**The Store - 854 Hunter Street  
Newcastle West**

## **BCA Assessment Report Report 2021/2075 R2.1**

**Prepared for DOMA  
October 2021**

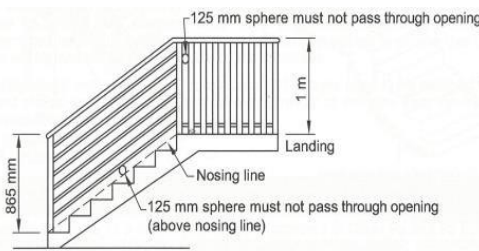
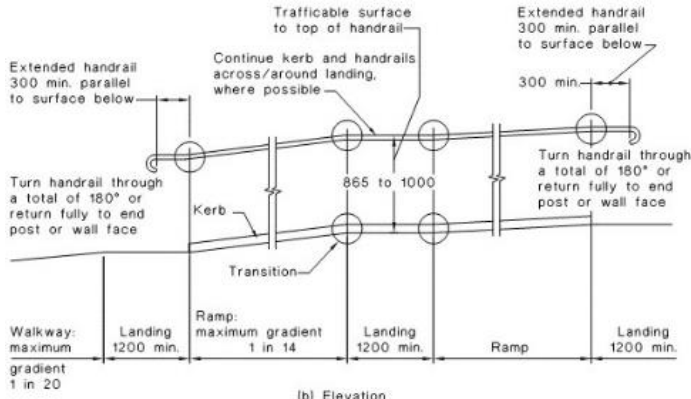
<b>D1.4</b>	<p><b>Exit travel distances</b></p> <p>No point on the floor must be more than 20m to an exit or a point in which travel in different directions to 2 exits is available, in which case, the maximum distance to 1 exit cannot exceed 40m.</p> <p>The distance to an exit OR point of choice to two alternative exits from the door of an SOU must not exceed 6m.</p>	<p>The nominated exits in the building are listed in appendix D1.4 of the report.</p> <p>The following areas have been identified with distances exceeding 20m to a point of choice:</p> <ol style="list-style-type: none"> <li><b>Office Floors (East Tower)  </b> Travel from the east tower to a point of choice exceeds 20m. In anticipation of a fitout the distances to a point of choice should be extended via an alternative solution report. Typically, an upper limit of 29m to a point of choice is the maximum permissible distance justifiable on a performance basis (office floors only).</li> <li><b>Level 005 function room / store room and lobby  </b> Travel to the a point of choice (when relying only on internal fire stairs) exceeds 20m.</li> <li><b>Outdoor Recreational Area Level 005  </b> Distances to a point of choice from the outdoor recreational area are assumed to exceed 20m. Additional details are required to be provided.</li> </ol> <p>The following areas have been identified with exit travel distances exceeding 40m:</p> <ol style="list-style-type: none"> <li><b>Outdoor Recreational Area Level 005  </b> Distances to a single exit from the outdoor recreational are assumed to exceed 40m. Additional details are required to be provided.</li> </ol> <p>The following areas have been identified with distances exceeding 6m to a point of choice or exit from the door to an SOU:</p> <ol style="list-style-type: none"> <li><b>Level 005 West Tower  </b> Up to 10.7m measured</li> <li><b>North facing apartments on the typical low-rise towers (East &amp; West)  </b> Up to 8.5m measured</li> <li><b>South facing apartments on the typical low-rise towers (East &amp; West)  </b> Up to 10.7m measured</li> <li><b>North facing apartments on the</b></li> </ol>	Does Not Comply

Clause	Description	Comment	Status
		<p><b>typical high-rise towers (East &amp; West)</b>   Up to 8.5m measured</p> <p>5. <b>South facing apartments on the typical high-rise towers (East &amp; West)</b>   Up to 10.7m measured</p> <p>6. <b>North facing apartments on the level 23 (East &amp; West towers)</b>   Up to 9m measured</p> <p>7. <b>North facing apartments on the level 24 (East &amp; West towers)</b>   Up to 9m measured</p> <p>8. <b>North facing apartments on the level 25 (West tower)</b>   Up to 9m measured</p> <p>9. <b>South facing apartments on the level 25 (West tower)</b>   Up to 7m measured</p> <p>10. <b>North facing apartments on the level 25 (East tower)</b>   Up to 7m measured</p> <p>11. <b>North facing apartments on the level 26 (West Tower)</b>   Up to 8.5m measured</p> <p>12. <b>North facing apartments on the level 26 (East tower)</b>   Up to 7m measured</p> <p>13. <b>North facing apartments on the level 27 (West tower)</b>   Up to 9m measured</p> <p>Plant room egress on level 04 is to be reassessed by the architect. Currently there are no means accessing the fire stair from the eastern portion (stair pressurisation room) without exiting the building and traversing a potentially non-trafficable surface.</p> <p>Extended travel distances will need to be addressed on a performance basis.</p>

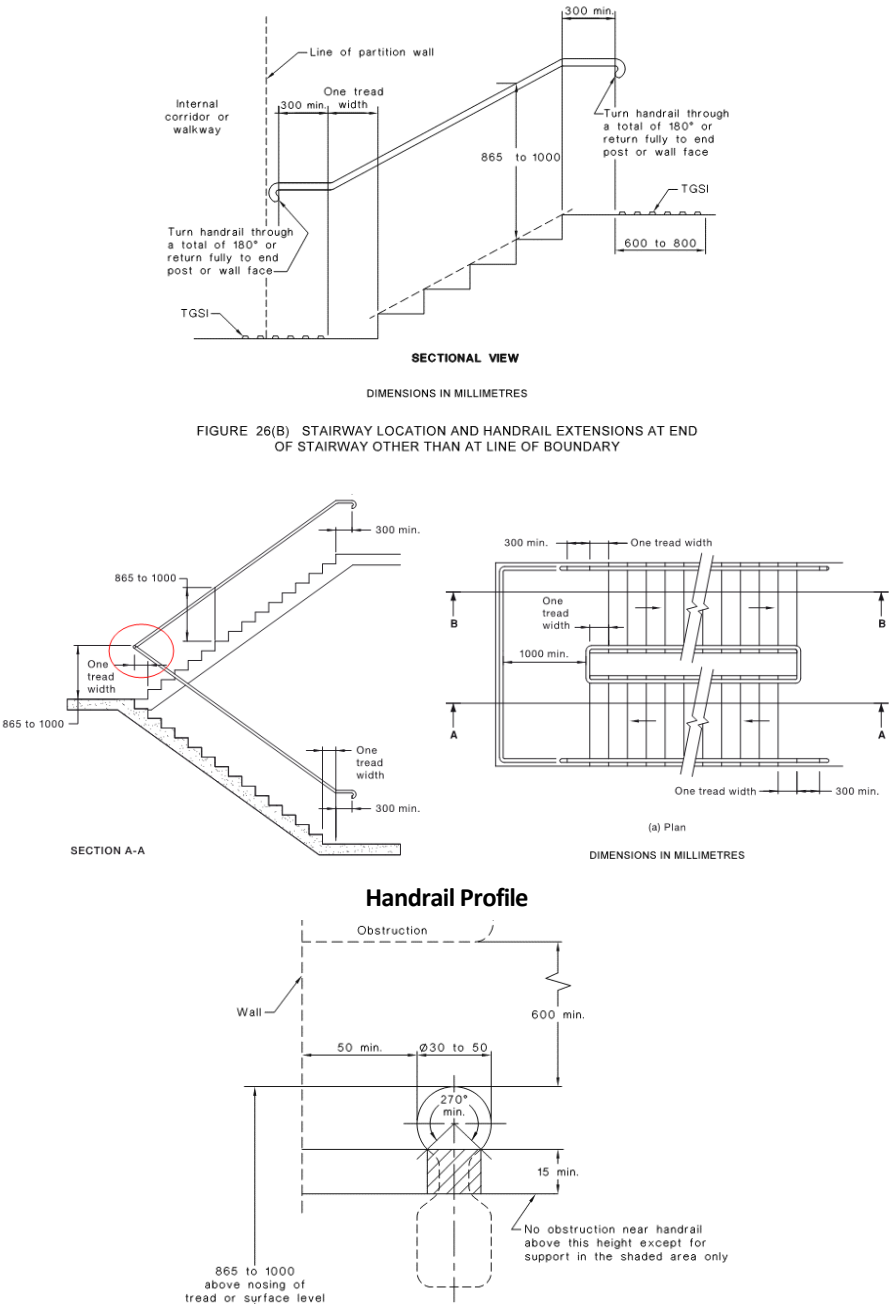
<b>D1.7</b>	<b>Travel via fire-isolated exits</b>	The Fire stairs also discharge into an area which is covered by more than a 3 <sup>rd</sup> of it's perimeter and requires travel to the road or open space at distances greater than 6m.	Does Not Comply

Clause	Description	Comment	Status
		<p>As the discharge of the exits currently necessitates passing within 6m of part of an external wall of the building the external wall &amp; openings within the wall will need to be protected in accordance with the requirements of this condition.</p> <p>The external wall within 6m of the path of travel to the road is required to achieve an FRL not less than 60/60/60 and any openings are required to be protected internally in accordance with C3.4 of the BCA.</p>	
<b>D1.8</b>	<p><b>External stairways or ramps in lieu of fire-isolated exits</b></p> <p>External stairs or ramps may be used instead of fire-isolated stairs to a building under 25m in effective height, subject to:</p> <ul style="list-style-type: none"> <li>• Stair to be non-combustible construction.</li> <li>• Exit doors onto the stair to be 1-hour fire rated.</li> <li>• Exit paths via the stair must be shielded if within 6m of openings in external wall of building.</li> </ul>	-	N/A
